MANDATORY SERVICE BULLETIN NO. MSBD4-018/2

DA 40 D: serial numbers D4.001 up to and including D4.017 equipped with Honeywell KAP 140 autopilot.

Autopilot.

BULLETIN NO: KC 140-M1
KC 140 Autopilot Computer

Figure 1
Test Harness

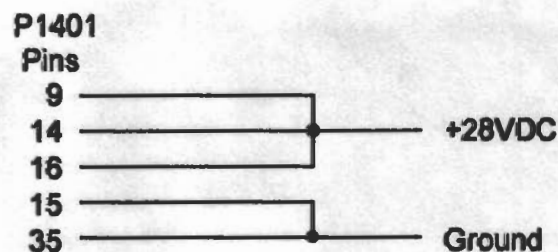
1. Build a test harness as shown in Figure 1 using the following parts. This test harness can be reused to program any number of KC 140 units according to this M bulletin.
 - A. 37-pin connector P/N 030-01175-0000
 - B. 37-pin hood P/N 030-02351-0023
 - C. 5 crimp sockets P/N 030-01157-0011
 - D. 2 screws P/N 089-06415-0006
 - E. Shop-supplied 22AWG wire

Figure 2
Location of P4 on the Main Board

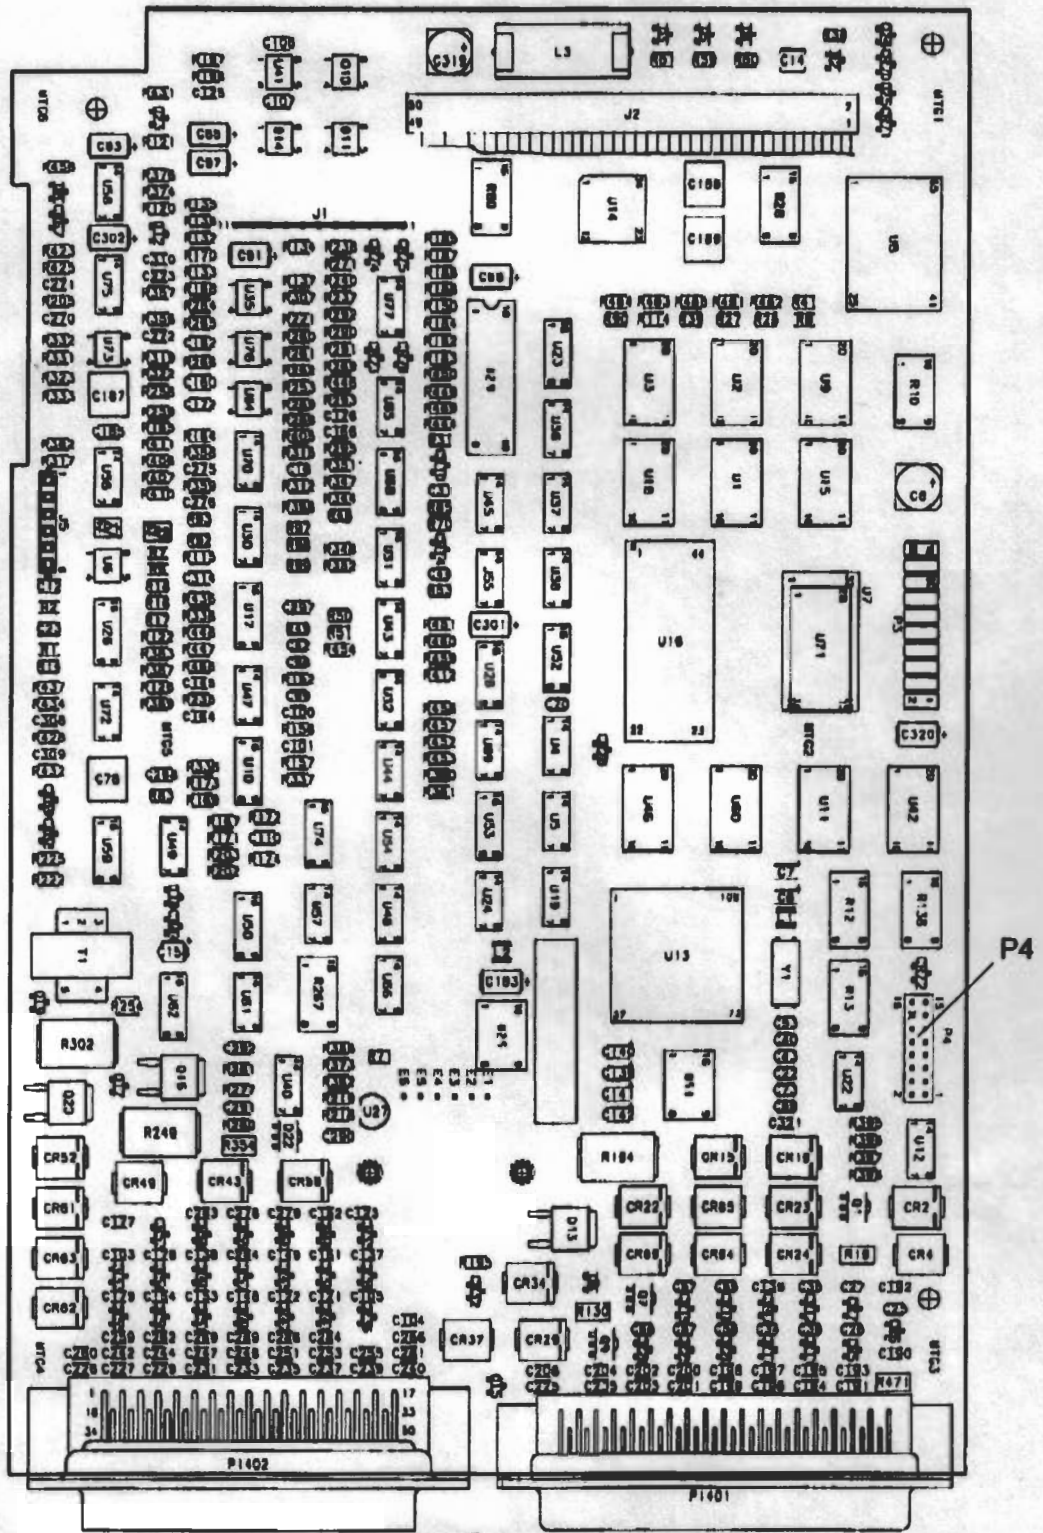
5. Connect the test harness from a 28-volt DC supply to J1401 on the KC 140.
6. Connect the ribbon cable from the Programming Interface Box to P4 on the Main Board. See Figure 2 for the location of P4.
